Appendix 15

Meadowbank and Whale Tail IRB Report No 32

January 30th, 2025

Reference: Report No 32
Meadowbank Independent Review Board (MBK IRB)
Site visit August 21st to 23rd, 2024 and meeting, Montréal, December 10th and 11th, 2024.

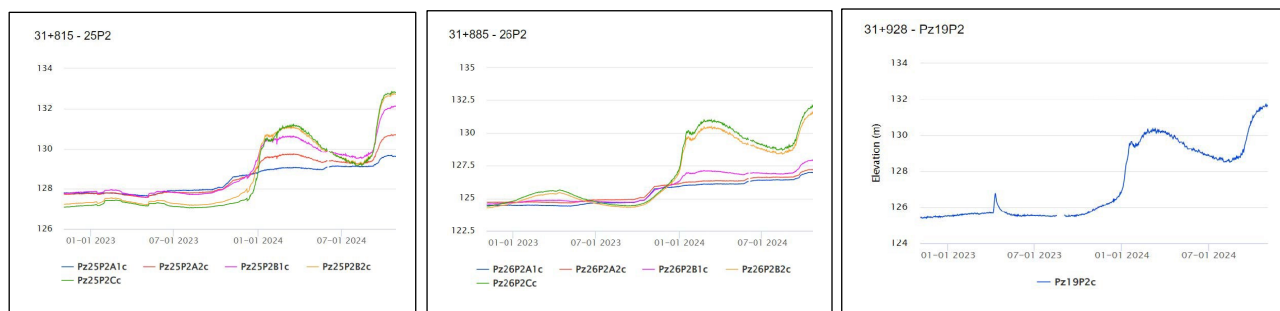
The comparison made on page 38 of part 3 of the December PowerPoint between piezometers at Stns. 31+815, 31+885 and 31+928 (copied below), indicates that piezometric pressures are highest at the former and decline towards the latter. Thus, the source of the seepage may be closer to the instrument at 31+815. All three instruments were installed in the fine filter material on the downstream side of the CSB cut-off. ***It is to be noted that soil-bentonite (SB) was used up to Stn. 31+790 and CSB in the deeper valley as far as Stn. 32+040. The SB is potentially more erodible, but the CSB could more easily hold open an ice generated fissure. The rate of seepage through a fissure would be controlled by the permeability of the fine filter. The migration of fine particles could lead to clogging of a fissure and stabilize the condition albeit with a non-zero residual flow.***
